Classification Society Tug Review for PWSRCAC

Prince William Sound Regional Citizens' Advisory Council

Report No./DNV Reg No.: / 1392NFK-7
Rev 1, 2011-10-24

Figure 1: Steering force at 10knots

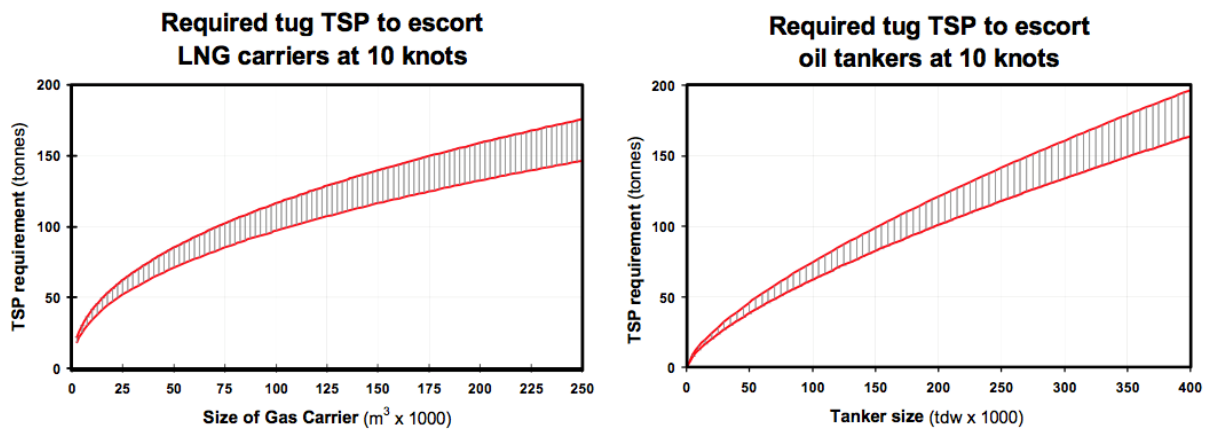
Each ship has unique steering characteristics and rudder forces at different speeds and rudder angle. IMO has issued rules for ships’ manoeuvrability (IMO 751 – 10/10 zigzag manoeuvre criterion), and published graphs showing steering forces for different tanker sizes at 10 knots. These graphs can be used to give a coarse estimation of what tanker sizes the tugs are capable to handle, provided that the Steering force of the tugs are known.
